IMMINGHAM EASTERN RO-RO TERMINAL

SUPPLEMENTARY CONSULTATION REPORT

PINS Reference – TR030007
October 2022

Figure 4:
Marine Infrastructure Changes

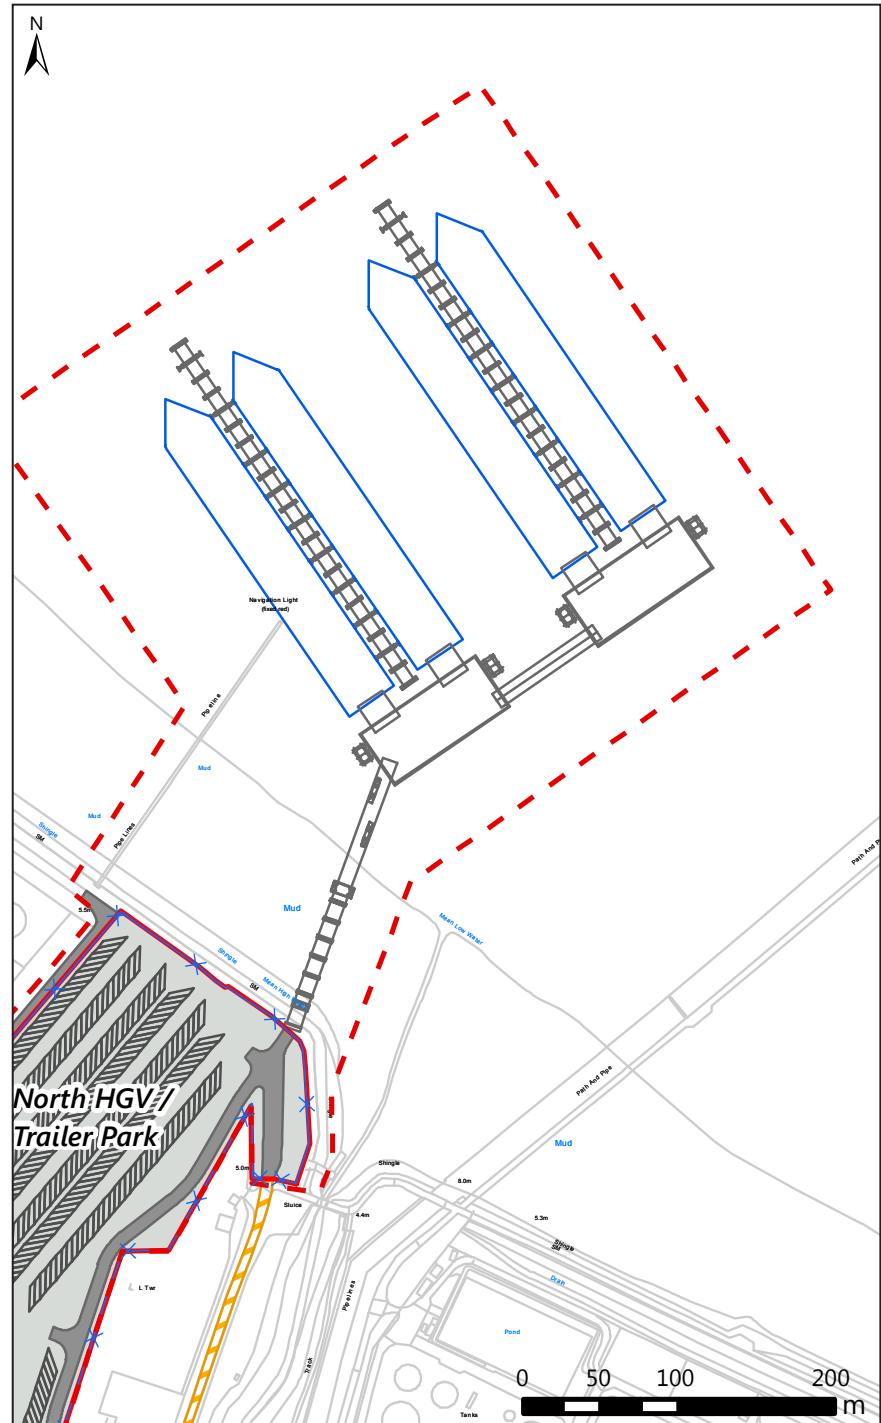
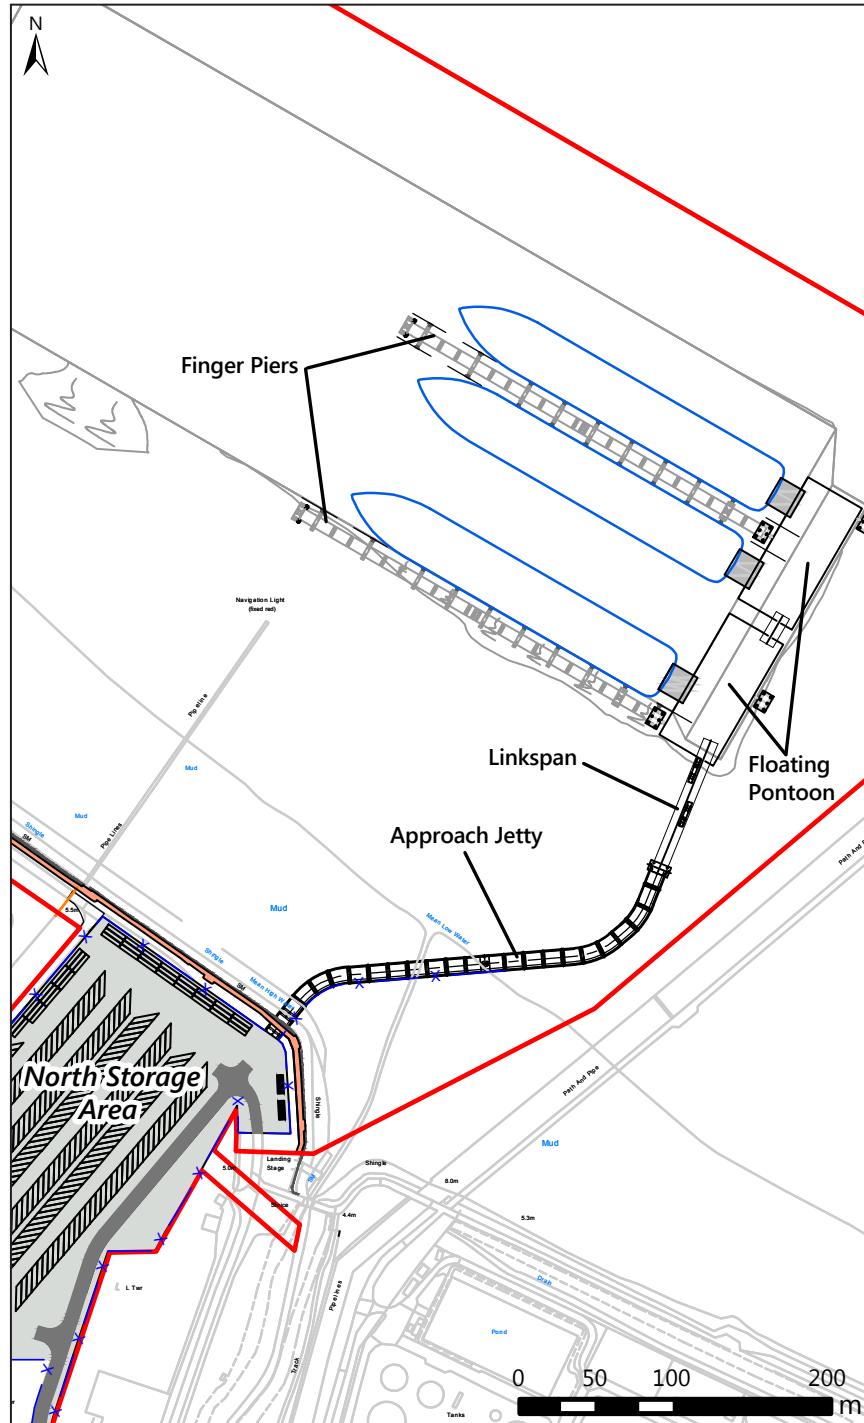
- 8.19 ***Approach jetty*** – As far as the approach jetty is concerned, the scheme as described in the PIER looked to the construction of a straight line approach jetty. It was, later decided, however, for practical reasons in terms of protecting existing port infrastructure, to amend the line of the jetty by the introduction of a curve in an easterly direction. This change was indicated in plan in both the Spring and Summer IERRT Newsletters.

- 8.20 This curve in the approach jetty has, however, now been further modified by a straightening of the jetty at its northern end, furthest from the foreshore, which has the immediate environmental benefits of enabling ABP to remove the second linkspan which has the benefit of reducing piling.

- 9.12 Figure 4 shows this part of the development as was described in the PEIR alongside marine layout as now proposed.
 - 9.13 The effects of the changes to the environmental impact as a direct consequence of this reduction of berths, together with the slight realignment of the three remaining berths and the realignment of the approach jetty, are considered in Section 17 of this Report.

Figure 5:
Removal of Storage Area

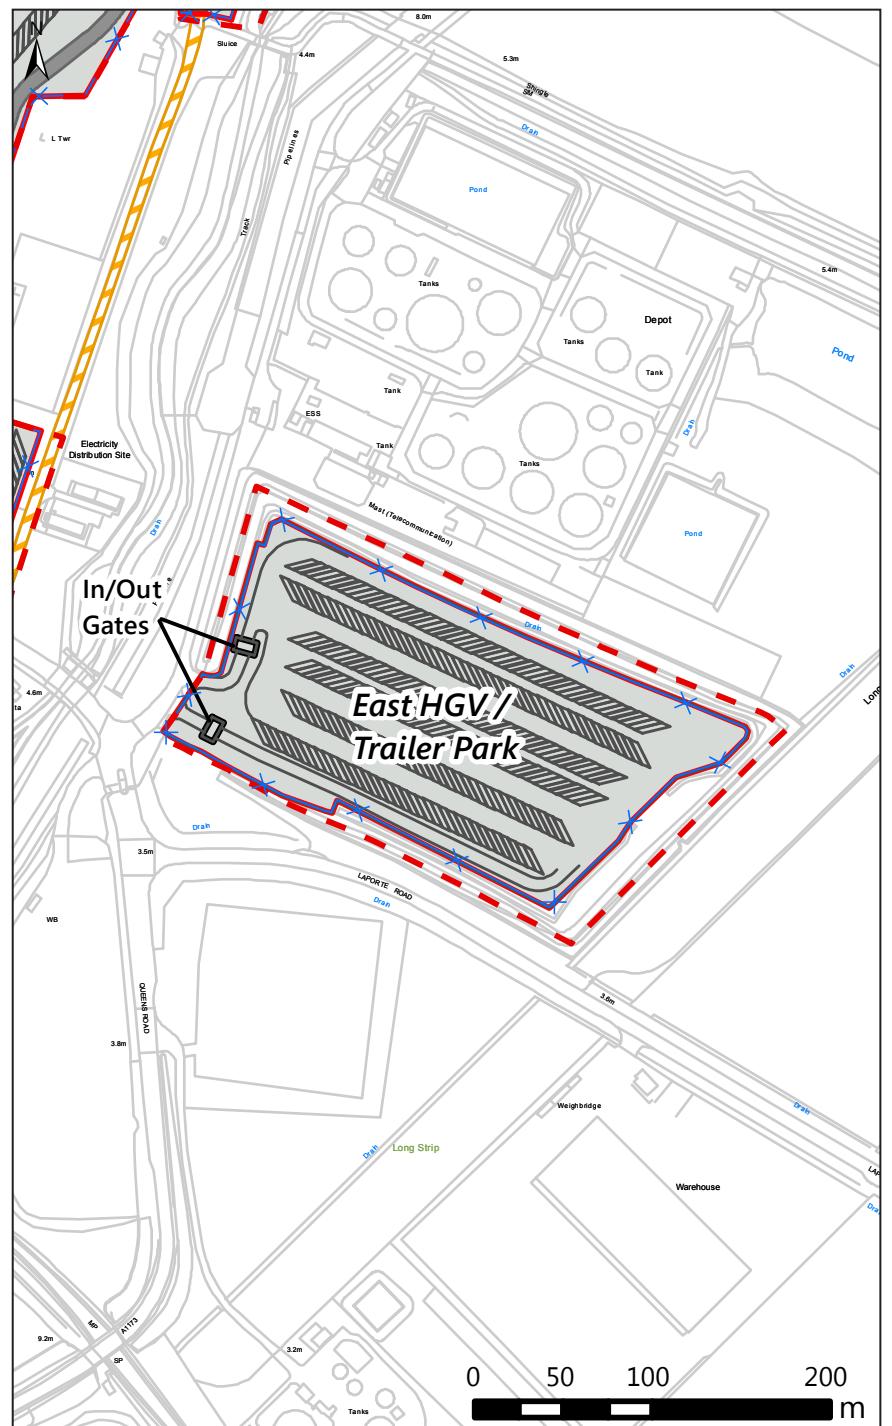
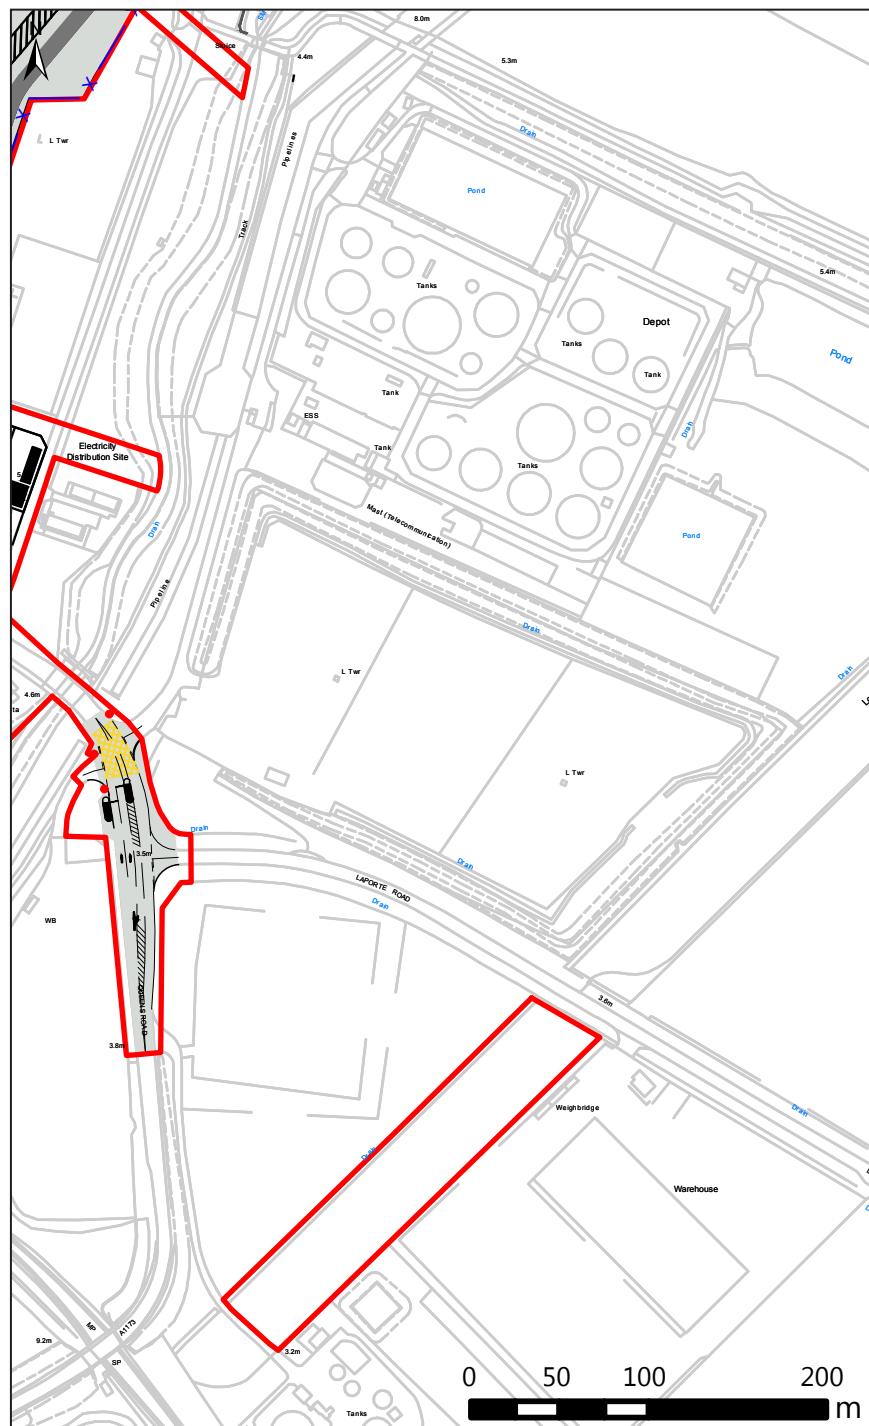
- 10.3 The decision has, therefore, been taken to remove from the IERRT scheme an area of storage land within the port estate but to the east of the main IERRT terminal site and separate from it.

- 10.8 To assist in understanding this change, Figure 5 shows this element of the development as detailed in the PEIR alongside this element as now proposed.

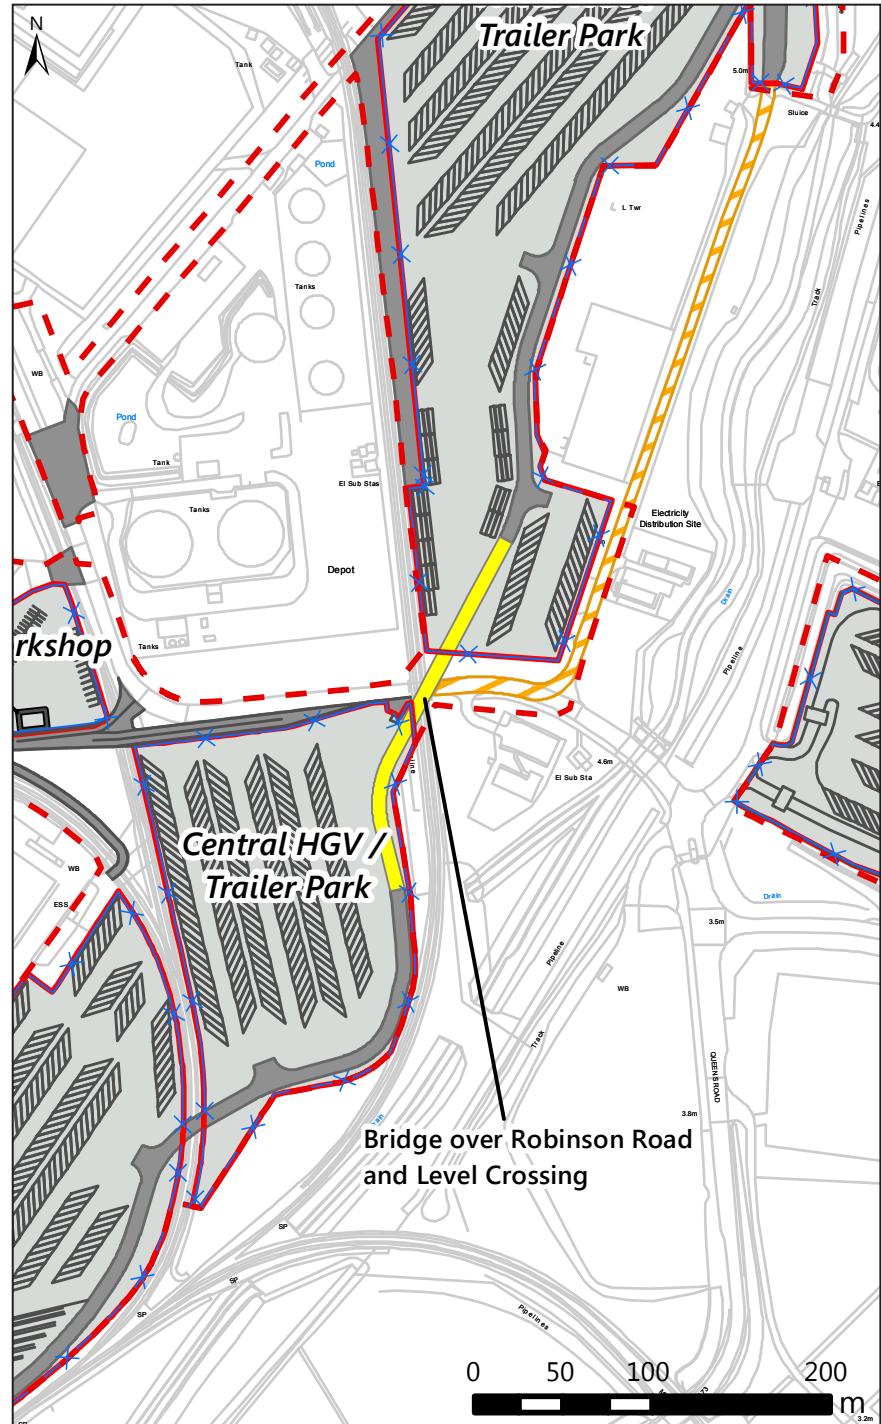
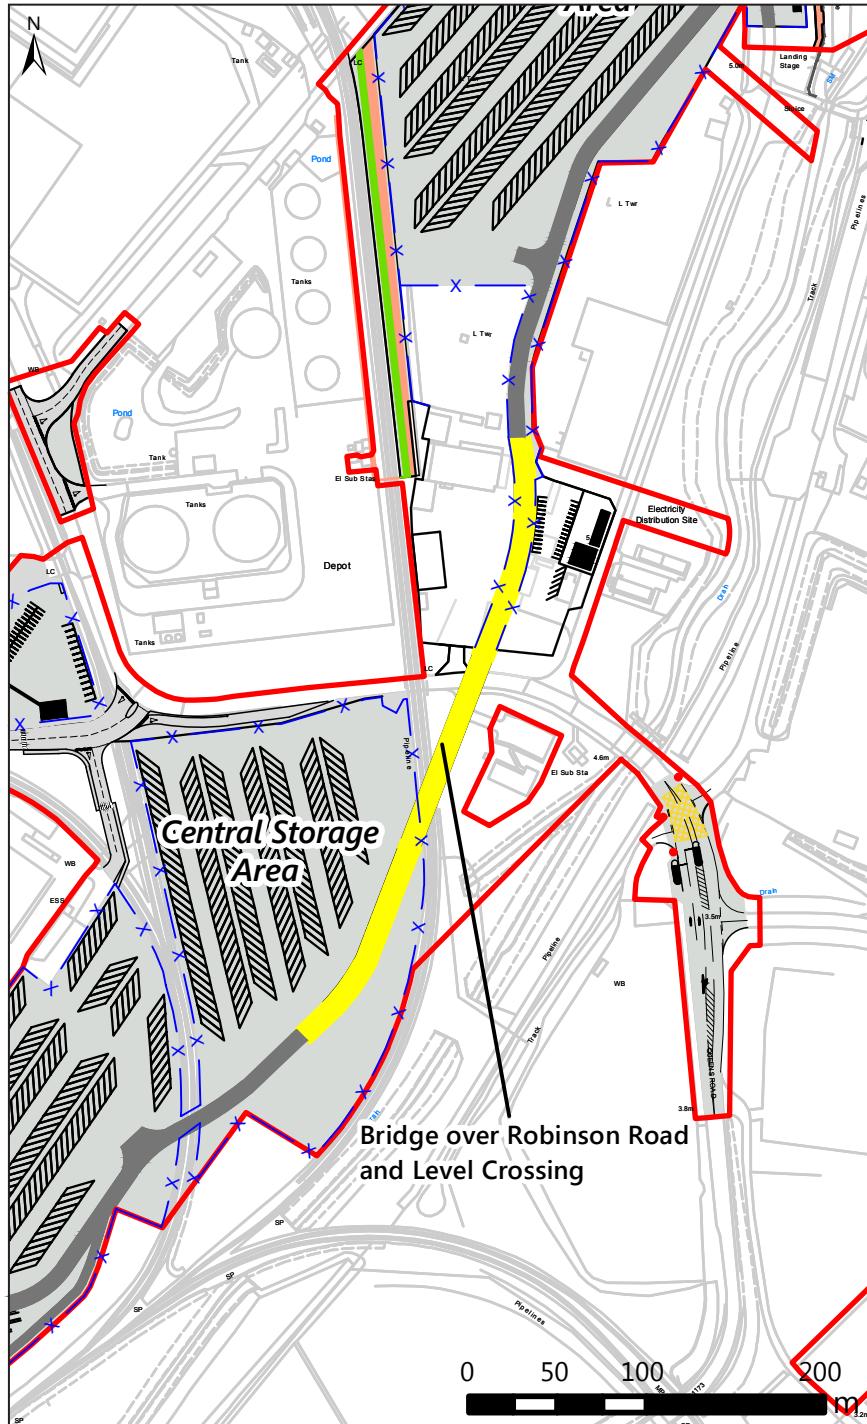
- 8.6 A slight realignment of the internal bridge has been effected in order to provide additional space for one of ABP's tenants who will remain within the Port but who would otherwise have lost some of its land as part of the IERRT Project.

- 11.6 Whilst developing the refinements to this part of the scheme the decision was also taken to remove the optional outbound gate that was previously to be located just to the north of the proposed bridge onto the East Riverside port road.

- 11.8 To assist in understanding this refinement to the scheme, Figure 6 shows the alignment of the bridge as originally proposed in the PEIR alongside what is now being proposed as part of the application.

Figure 7:
East Gate Improvements

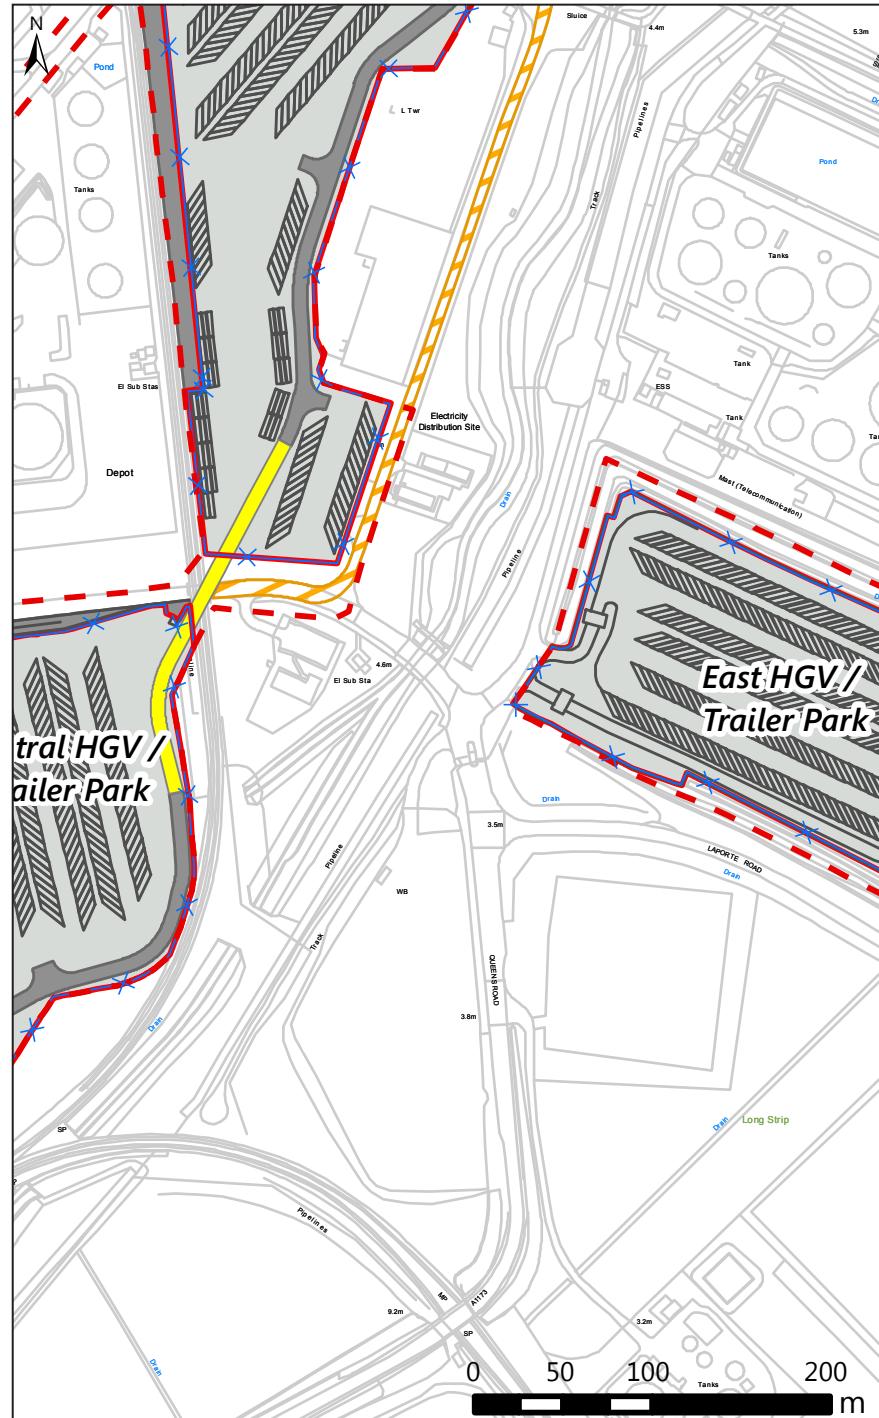
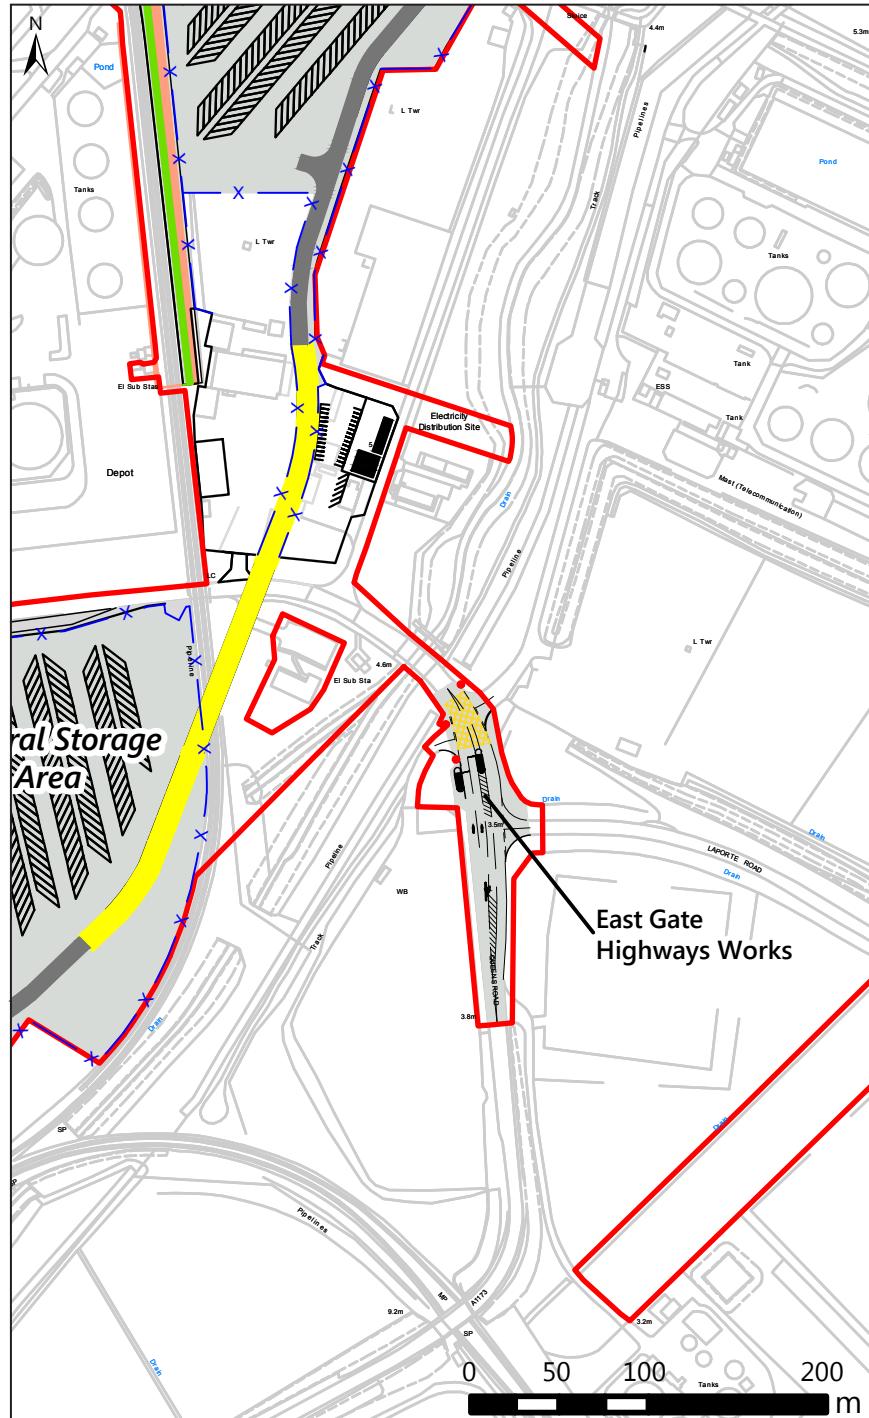
- 12.1 As part of the IERRT project, a capacity improvement will be made to the East Gate security entrance to the Port. This is required in order to facilitate the additional movement of vehicles through the East Gate into the Port. The existing gate house will be demolished and the existing entrance will be widened to accommodate an extra inbound lane with a newly constructed security gate house.

- 12.9 To assist in understanding this improvement, Figure 7 shows this element of the development as detailed in the PEIR alongside this element as now proposed.
